SSD Re-alignment ???

FLANGE CENTRES (HALL COORDINATES)

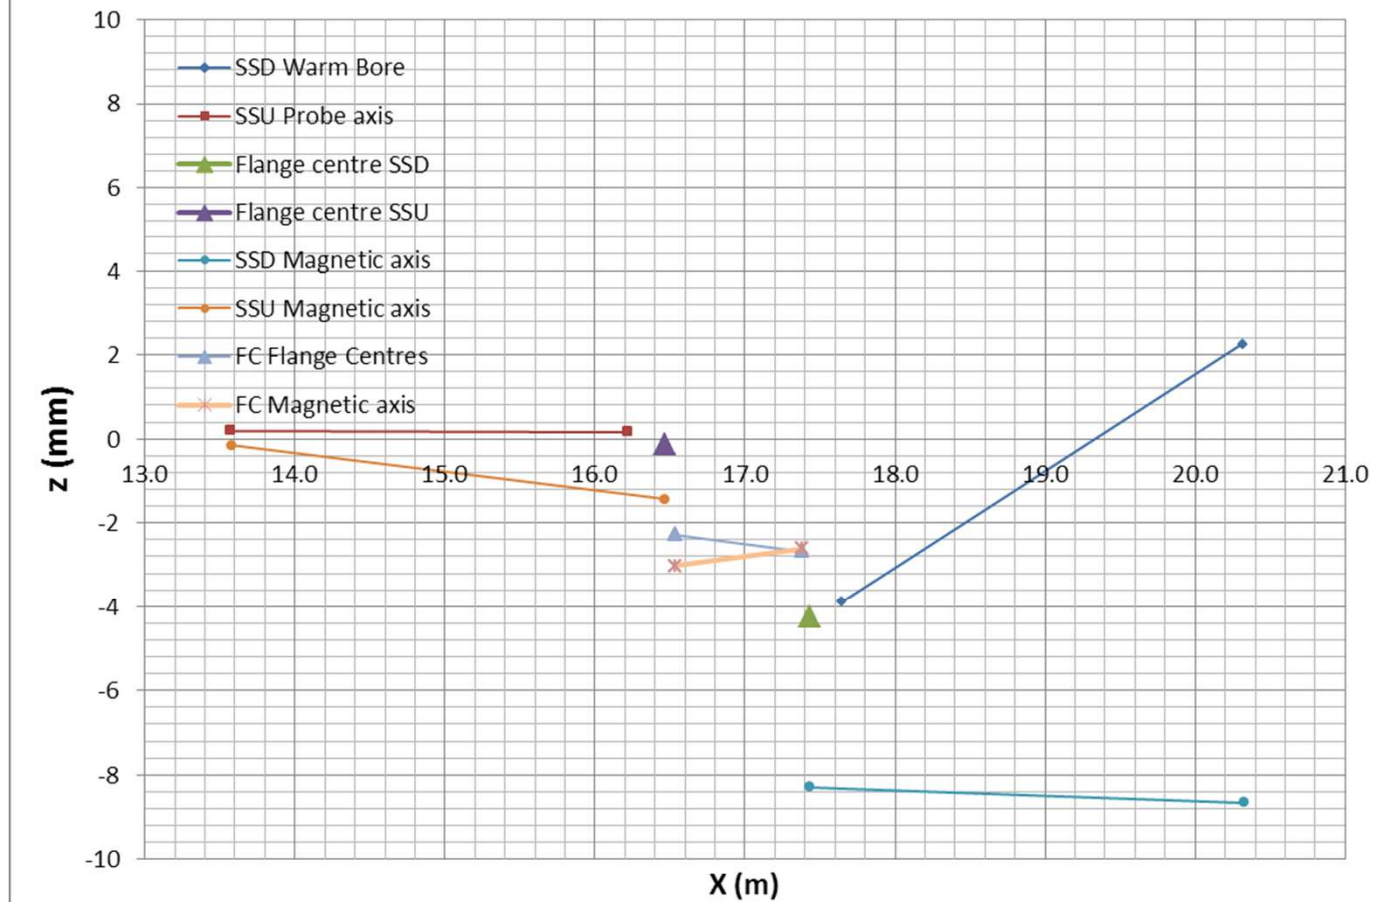
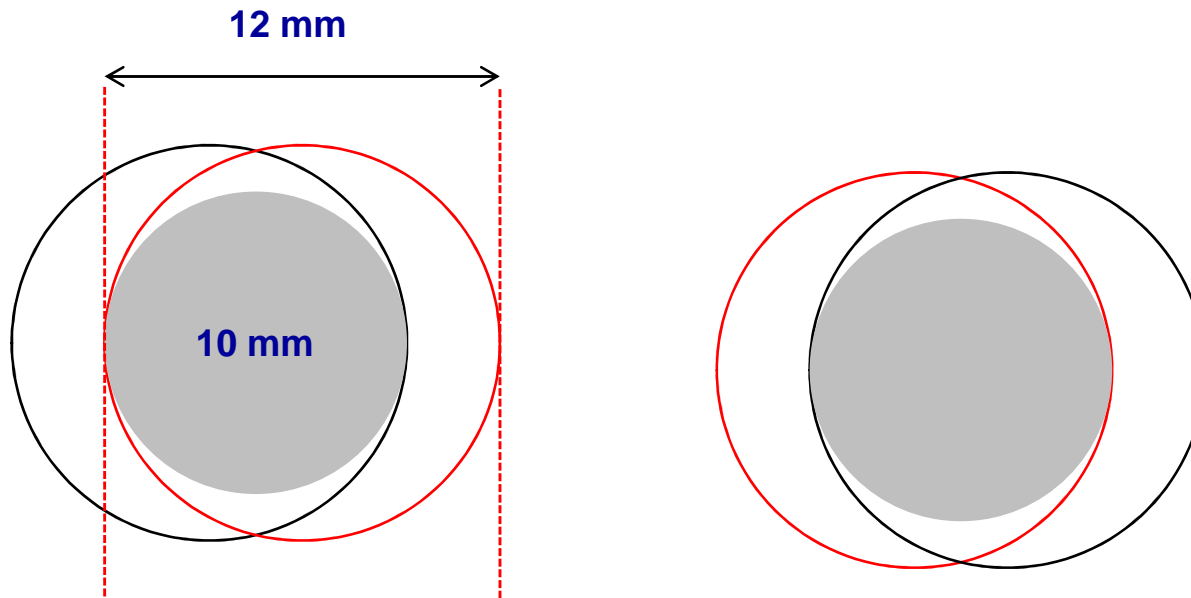
- **My understanding (*my apologies if I am mistaken*):**
 - **SSU was surveyed & *aligned* into position**
 - **By the surveyors**
 - **SSD was placed on beam line to < 1mm**
 - **No real attempt to align it**
 - **Centre of flange:**
 - **~ 2mm off in Y and ~ 4mm low in Z**
 - **We already knew SSD magnetic axis was ~4mm below flange centre**
 - **It was a struggle to couple the Bellows and the FC**
 - **The FC + Bellows had to accommodate the drop of 4mm between SSU & SSD flanges**

10 mm bolt in two 12 mm holes allows +/- 2mm at each interface

Four interfaces:

SSU	- Bellows
Bellows	- FC
FC	- Bellows
Bellows	- SSD

(Yes, I know that the flanges & bellows are not very well made and we won't get all that – but must have some slack →)
